SUBJECT: **Request for Modification of Section 404 Individual Permit and Section 401 Water Quality Certification** for the proposed Winston-Salem Northern Beltway Eastern Section from US 158 to I-40 Bus/US 421, Forsyth County, Division 9. WBS Element No. 34839.1.2, TIP Project No. U-2579B.

**Reference:** Section 404 Individual Permit – Action ID No. SAW-2008-03183, issued June 17, 2014 and modification issued July 2, 2014.  
Section 401 Water Quality Certification – NCDWR Project No. 2014090 issued April 11, 2014 and modification issued July 28, 2014.

**PERMIT DRAWING  
MODIFICATION FOR  
SITE 23 AND 28**

| PROJECT REFERENCE NO.<br><b>U-2579B</b>                                  | SHEET NO.<br><b>25</b> |

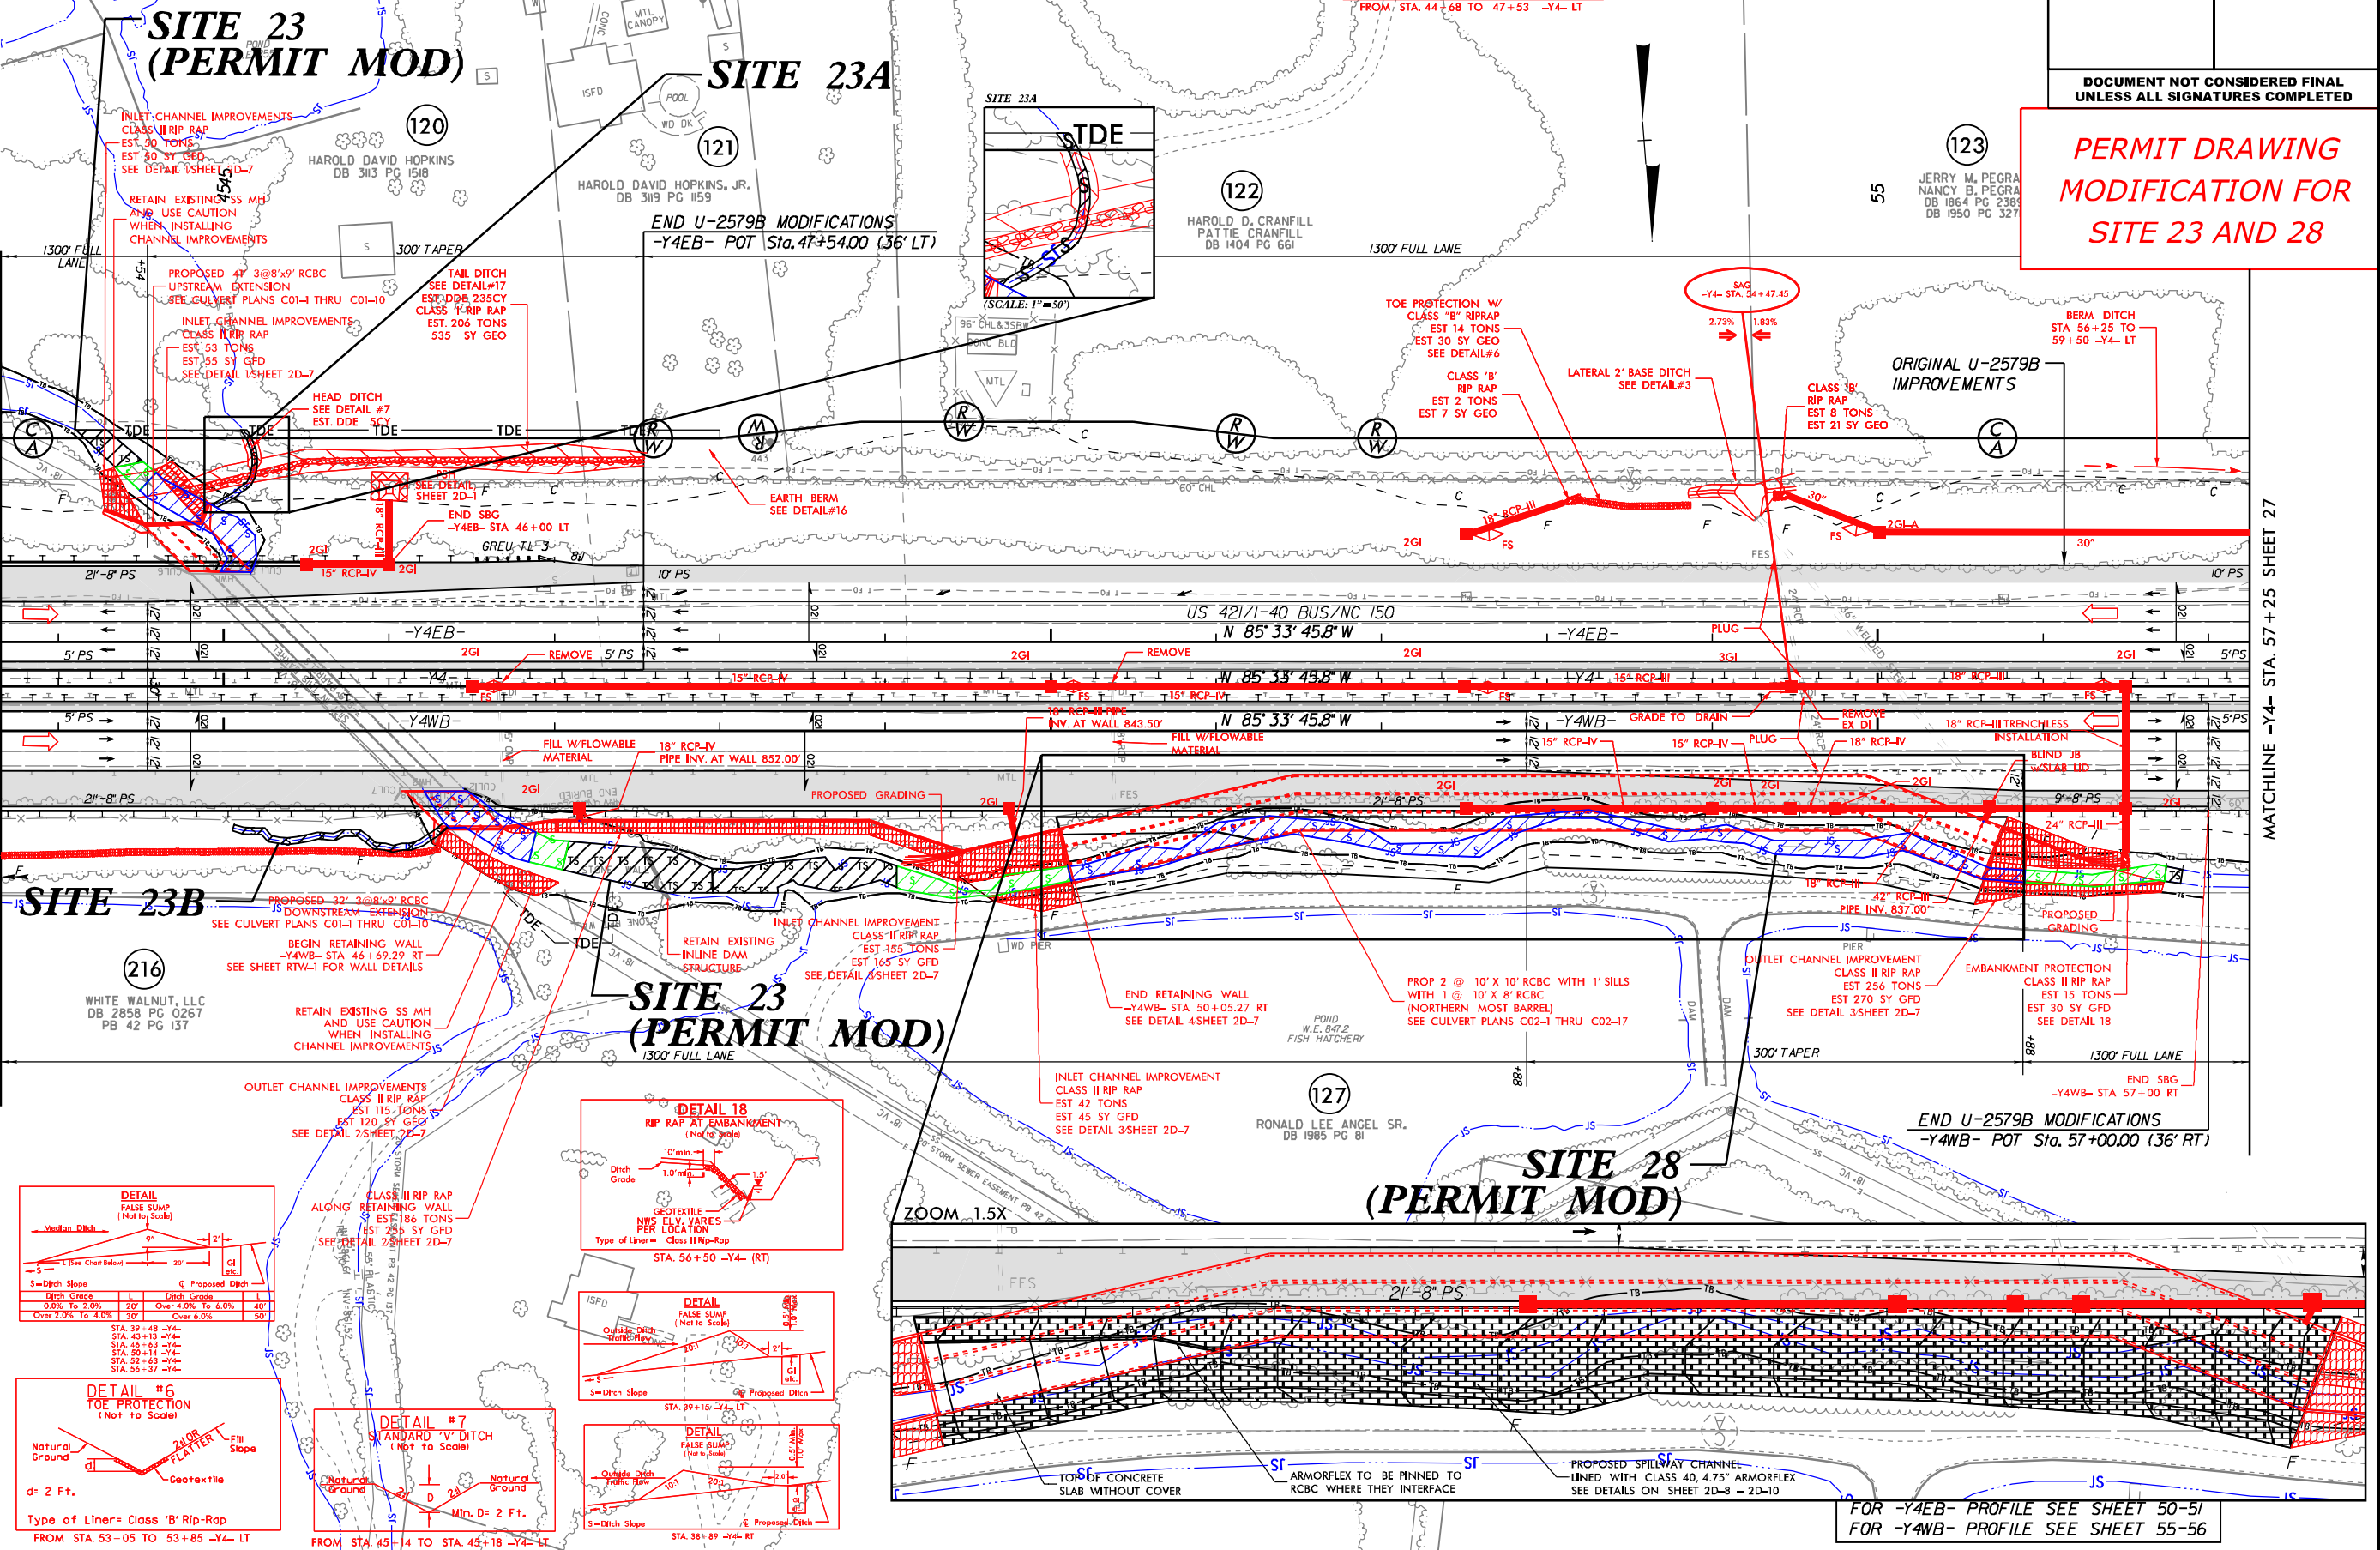
At sites 23 and 28, Smith Creek runs between existing westbound I-40 Business (US 421) and the adjacent ponds for the Windmill Fish Hatchery in a tightly restricted channel. We propose to extend the existing culvert at site 23 and place Smith Creek inside a 3 barrel box culvert at site 38. See Table 1 for previously permitted and revised impacts at permit sites 23 and 28.

Since Smith Creek was surveyed in 2008, the stream alignment has shifted closer to the road or the adjacent ponds in multiple location. In some areas adjacent to I-40 Business (US 421), Smith Creek has migrated to the toe of the existing fill for the roadway, and in other areas it has migrated into the toe of fill for the fish ponds. Due to the stream migration and instability, long term stability of the road fill and fish ponds are at risk. The permitted plans involved the construction of rock plating with retaining walls. However, when the fill slopes are extended for the guardrail installation and the onramp to the Winston Salem Beltway from I-40 Business/ US 421, the planned toe for the rock plating and walls are now in the active stream channel in some locations. If we installed the walls per plan, Smith Creek would be pushed in closer proximity to the ponds, and would threaten the stability of the ponds. Therefore, NCDOT plans to extend the existing triple barrel culvert under I-40 Business/ US 421 and install a triple barrel culvert in

Smith Creek between the road and the ponds. Additionally, the upstream end of the existing culvert will be lengthened by approximately 12' to accommodate traffic shifts during construction which will also result in a better alignment with the existing stream. These impacts were considered as part of the permanent impacts from the culvert extension in the original permit application, so the impact type won't change.

REVISIONS  
 CONSTRUCTION REVISION - 11/16/18 - REVISED ROADWAY AND HYDRAULIC DESIGN TO ACCOUNT FOR FUTURE U-5760 PROJECT,  
 BEGINNING AT -Y4- STA. 35+50.00 - R5H

**PERMIT DRAWING  
MODIFICATION FOR  
SITE 23 AND 28**

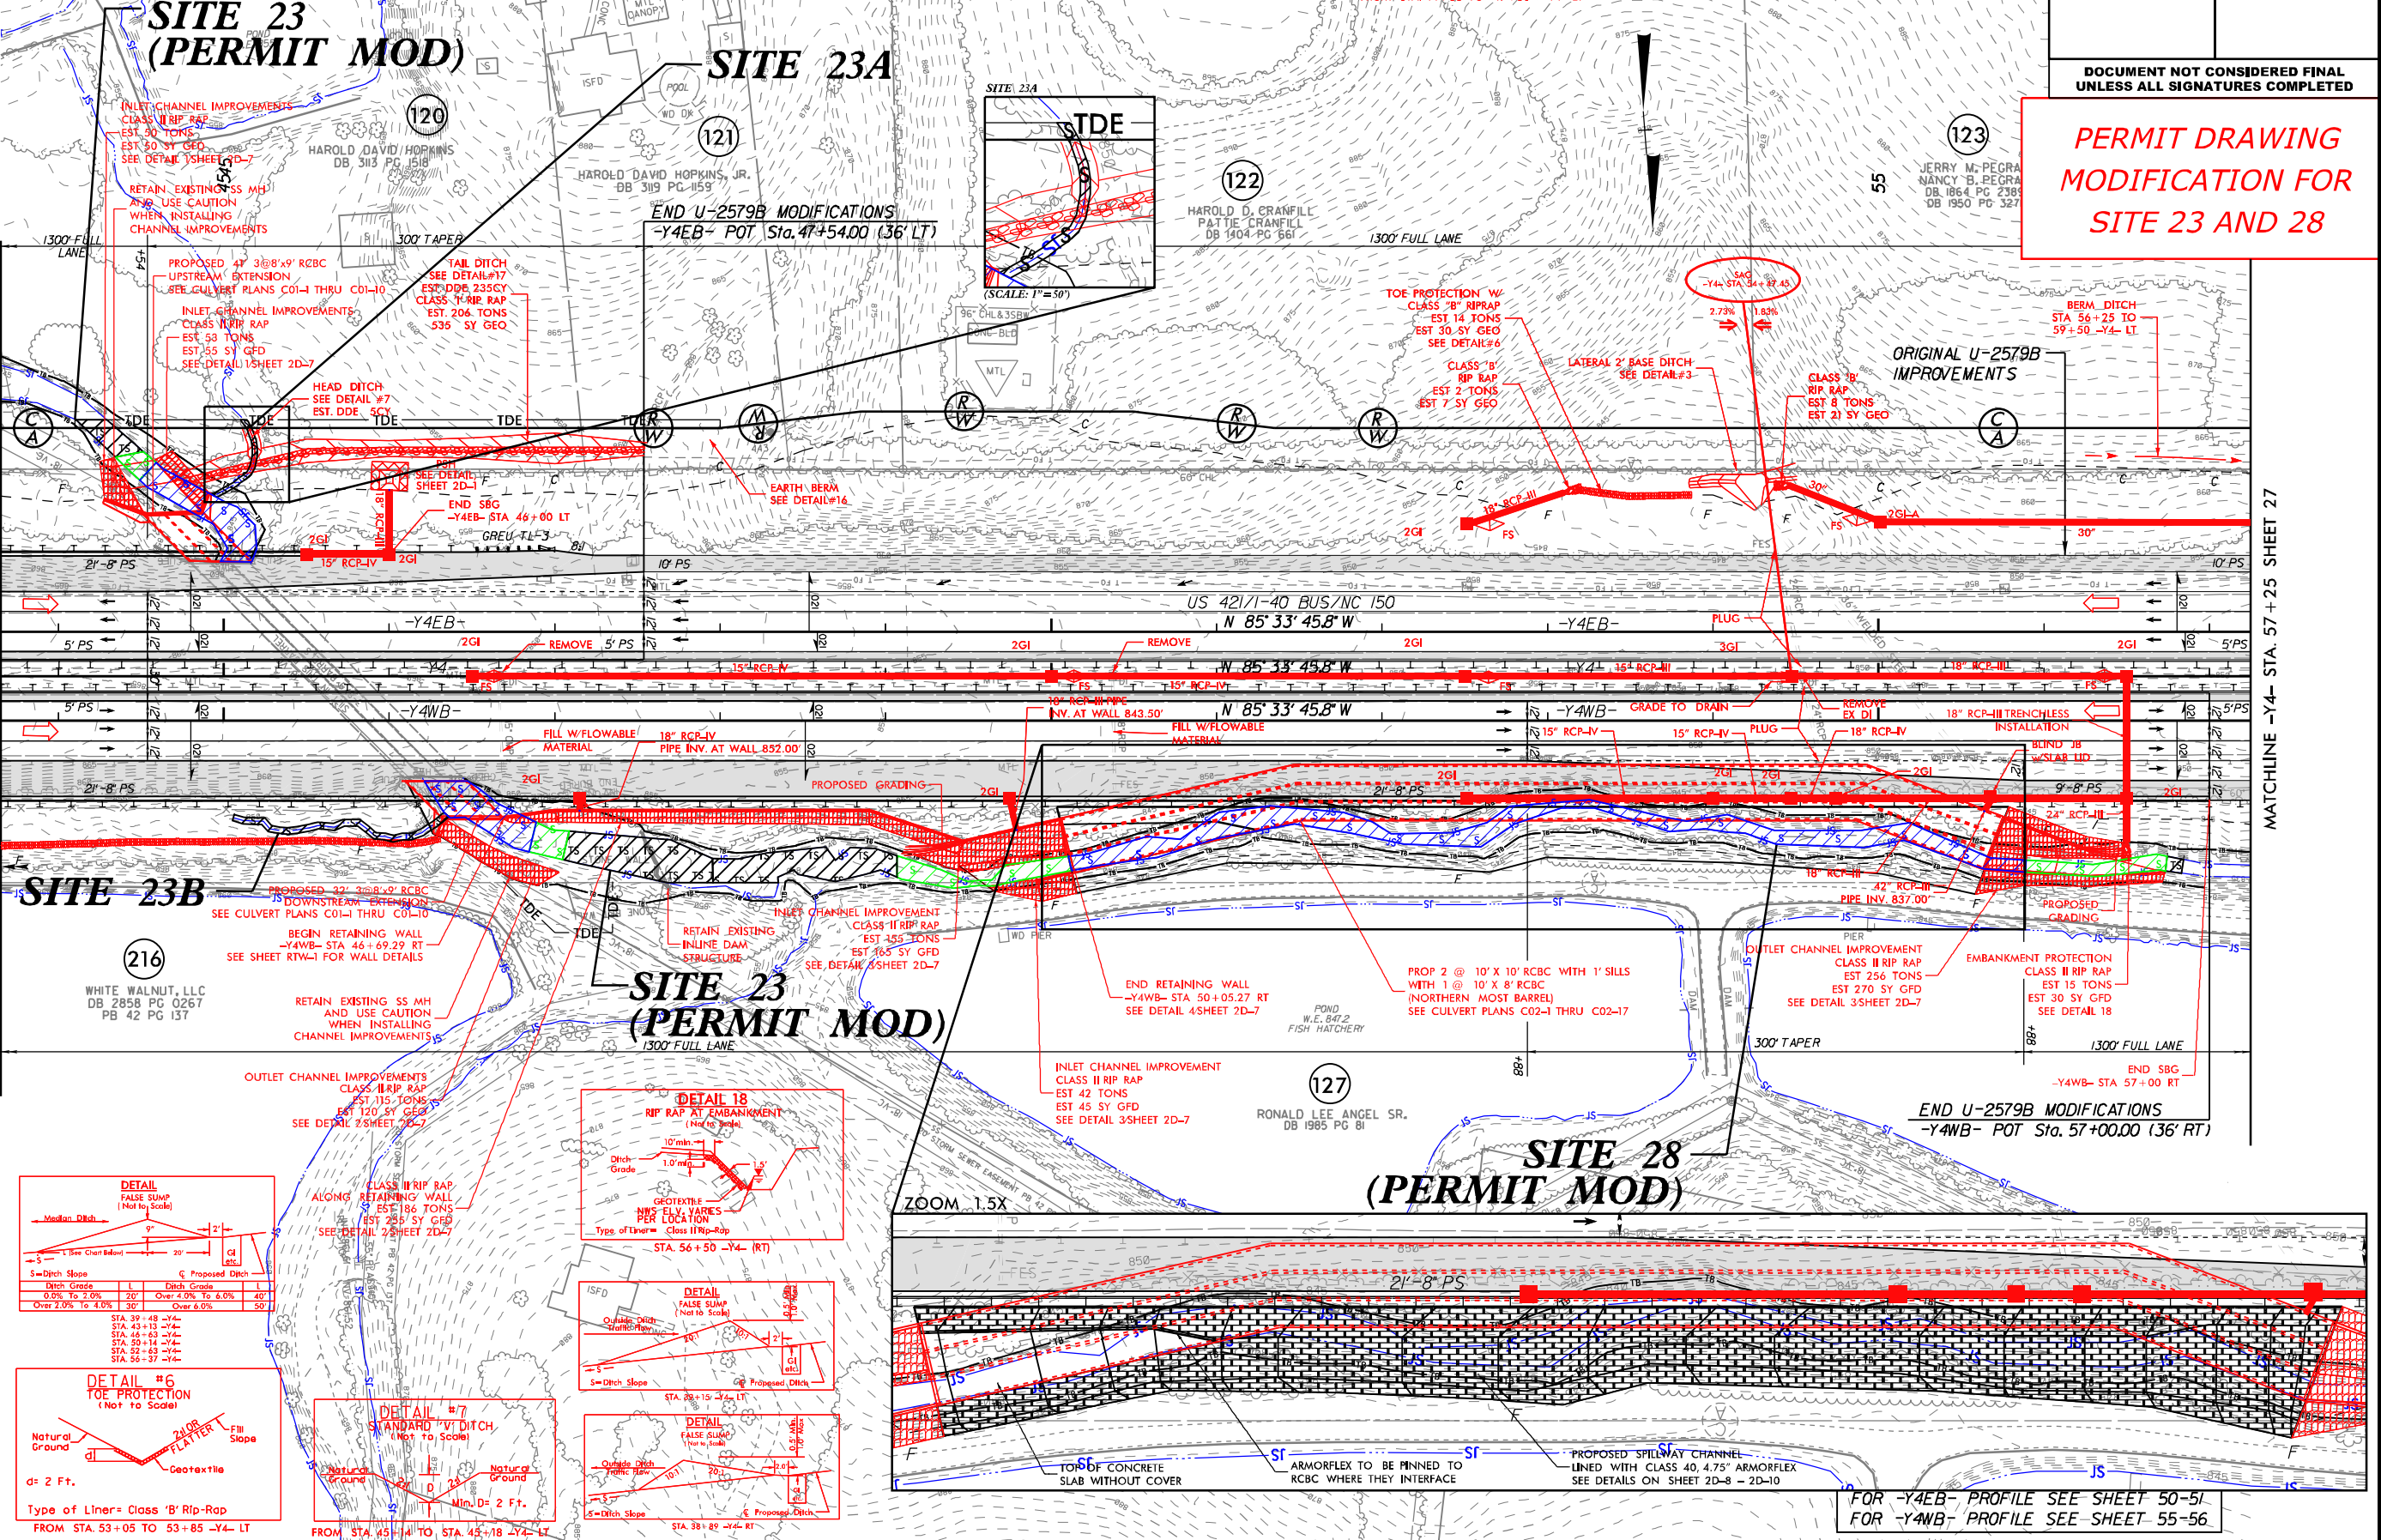
At permit site 28, the low flow barrel will not be buried 1' below the stream bed. The bed of Smith Creek has a predominately bedrock bottom making culver burial infeasible. There will be a spill over channel constructed on top of the exposed portion of the culvert, and it will be lined with Armorflex in the event of overtopping. The outlet of the low flow barrel will have a rip rap pad of Class II to prevent scour in the event of overflow. The 2 high flow barrels will have 1' concrete sills at the inlet and outlet. Floodplain benches will be constructed with Class II rip rap at the inlet and outlet. The high flow barrels will be backfilled with native material and/or Class I rip rap.

CONSTRUCTION REVISION - 11/16/18 - REVISED ROADWAY AND HYDRAULIC DESIGN TO ACCOUNT FOR FUTURE U-5760 PROJECT, INCLUDING RETAINING WALL AND CULVERT ON NORTH SIDE OF -Y4-. MATCHLINE MOVED TO -Y4- STA 57+25 (FROM 56+61) TO ILLUSTRATE ALL CHANGES ON PLAN SHEET 26. - RSH
